SUNDRY NOTICES AND REPORTS ON WELLS
Do not use this form for proposals to drill or to re-enter an abandoned well. Use form 3160-3 (APD) for such proposals.

5. Lease Serial No. NMNM04557
6. If Indian, Allottee or Tribe Name
7. If Unit or CA/Agreement, Name and/or No.
8. Well Name and No. BIG EDDY UNIT DI4 268H
9. API Well No. 30-015-43283-00-X1
10. Field and Pool or Exploratory Area WILLIAMS SINK
11. County or Parish, State EDDY COUNTY, NM

XTO Permian Operating, LLC requests permission to change the casing/cement design per the attached drilling program.....

**PECOS DISTRICT
CONDITIONS OF APPROVAL**

11-3/4" x 8-5/8" x 5-1/2" 10M RSH-2 Wellhead
Assembly, With T-EBS-F Tubing Head

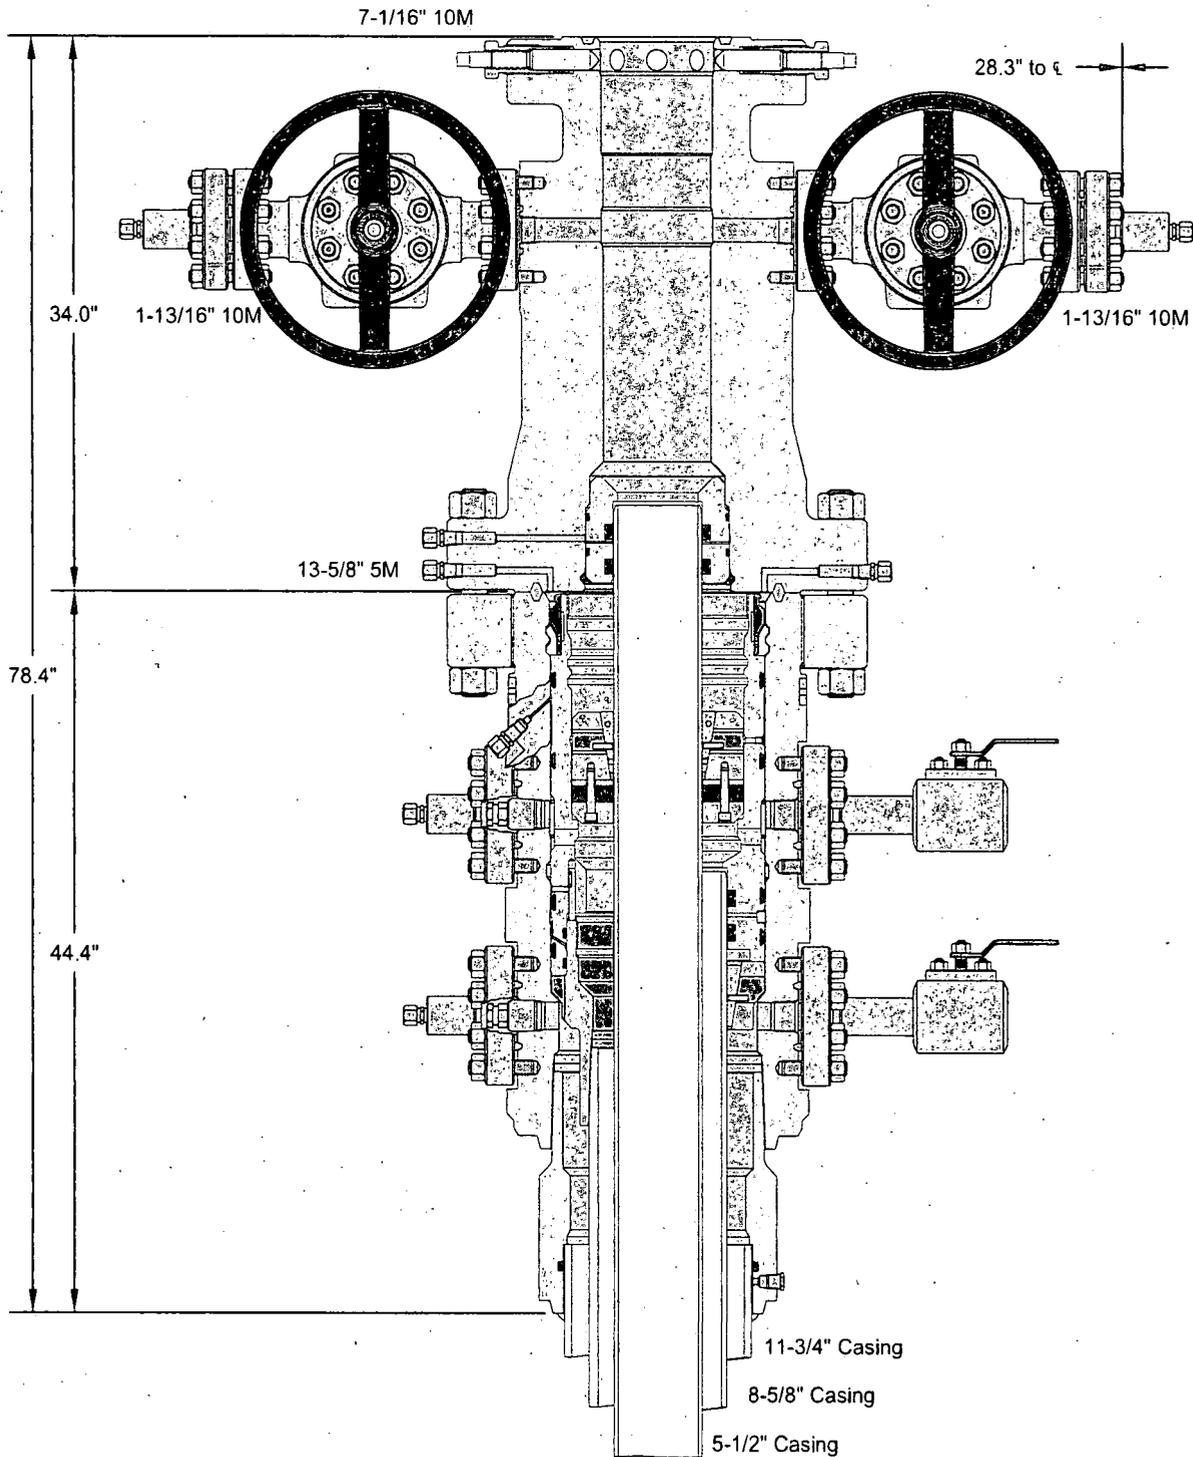
4. **Operator has proposed a multi-bowl wellhead assembly. This assembly will only be tested when installed on the 11-3/4 inch casing. Minimum working pressure of the blowout preventer (BOP) and related equipment (BOPE) required for drilling below the 11-3/4 inch casing shoe shall be 3000 (3M) psi.**

- a. **Wellhead shall be installed by manufacturer's representatives, submit documentation with subsequent sundry.**
 - b. **If the welding is performed by a third party, the manufacturer's representative shall monitor the temperature to verify that it does not exceed the maximum temperature of the seal.**

- c. **Manufacturer representative shall install the test plug for the initial BOP test.**
 - d. **Operator shall perform the intermediate 8-5/8 inch casing integrity test to 70% of the casing burst. This will test the multi-bowl seals.**

- e. **If the cement does not circulate and one inch operations would have been possible with a standard wellhead, the well head shall be cut off, cementing operations performed and another wellhead installed.**

GRADE D PRESSURE TEST CERTIFICATE

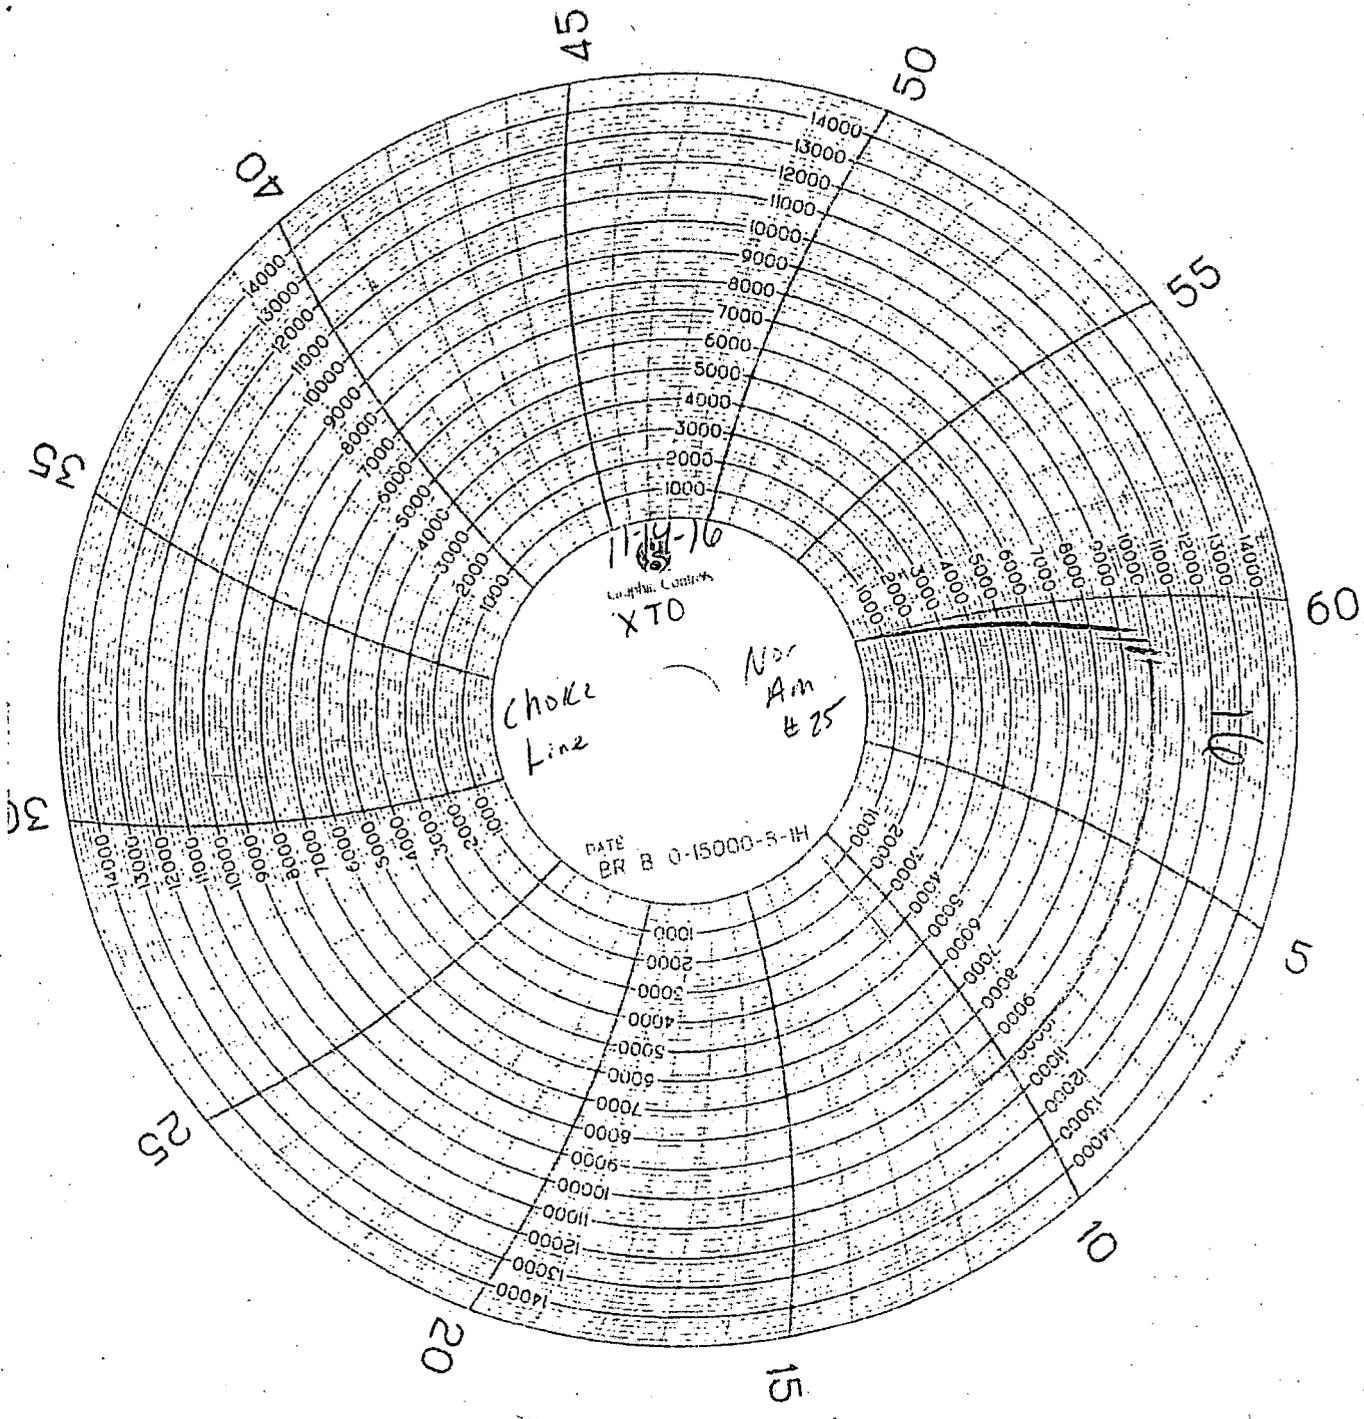
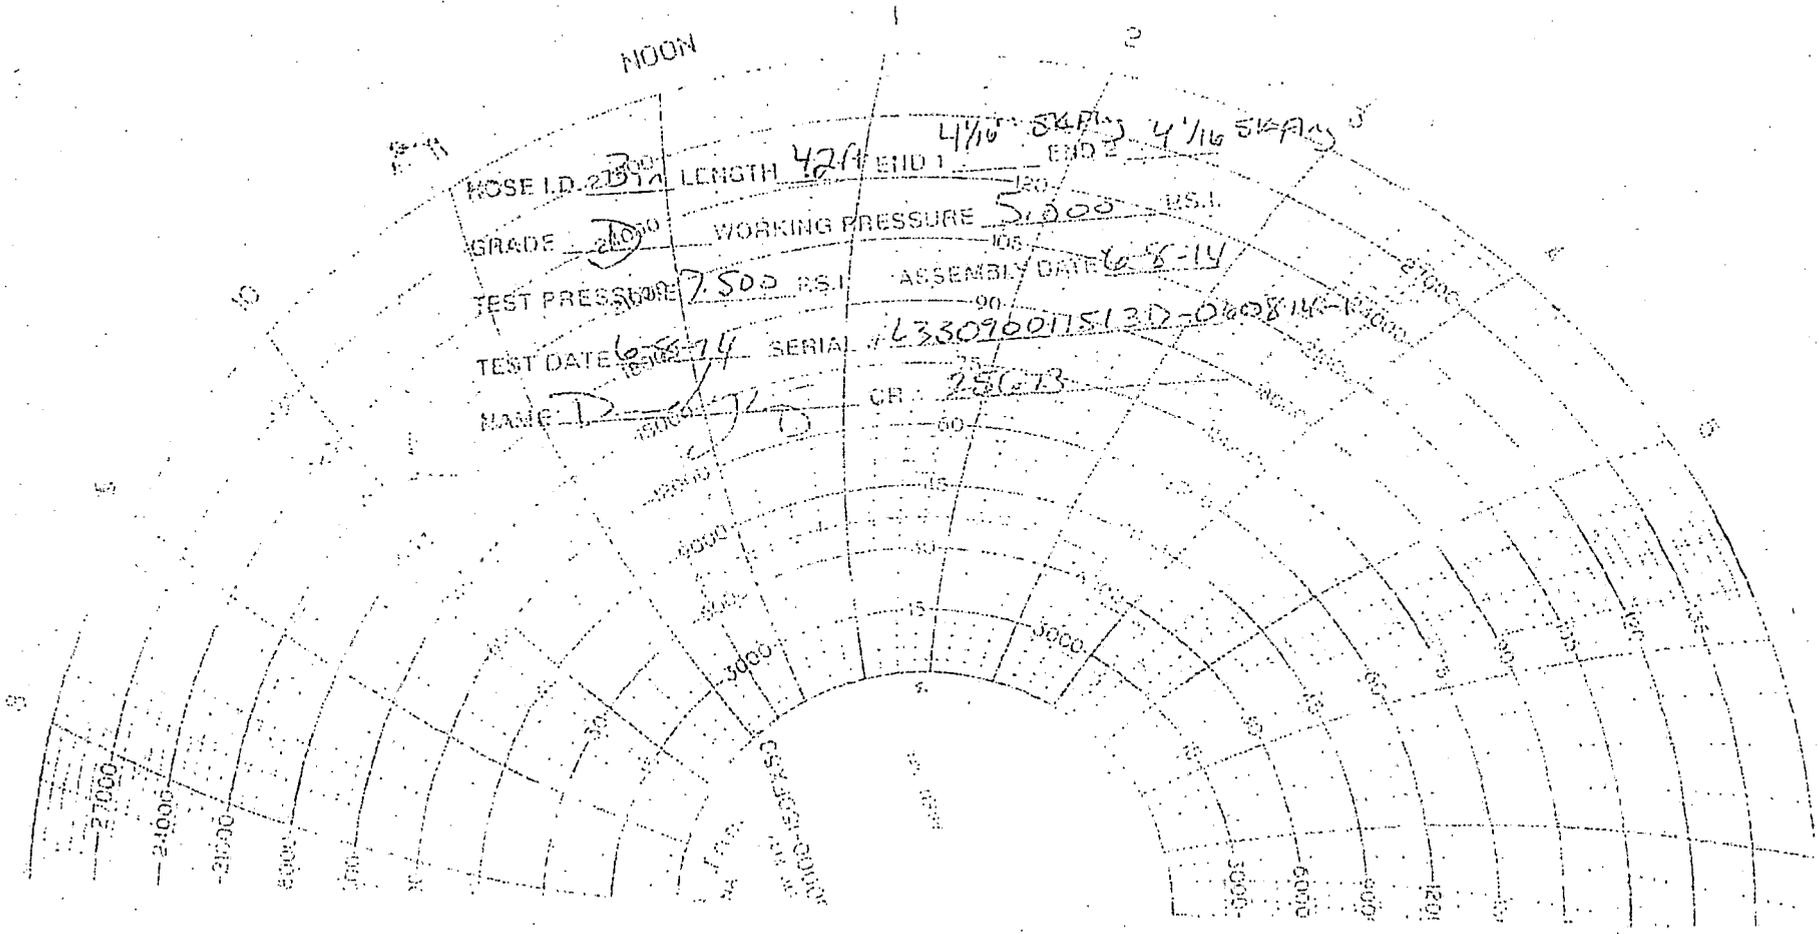
2. Variance approved to use flex line from BOP to choke manifold. Check condition of flexible line from BOP to choke manifold, replace if exterior is damaged or if line fails test. Line to be as straight as possible with no hard bends and is to be anchored according to Manufacturer's requirements. The flexible hose can be exchanged with a hose of equal size and equal or greater pressure rating. **Anchor requirements, specification sheet and hydrostatic pressure test certification matching the hose in service, to be onsite for review. These documents shall be posted in the company man's trailer and on the rig floor.** If the BLM inspector questions the straightness of the hose, a BLM engineer will be contacted and will review in the field or via picture supplied by inspector to determine if changes are required (operator shall expect delays if this occurs).
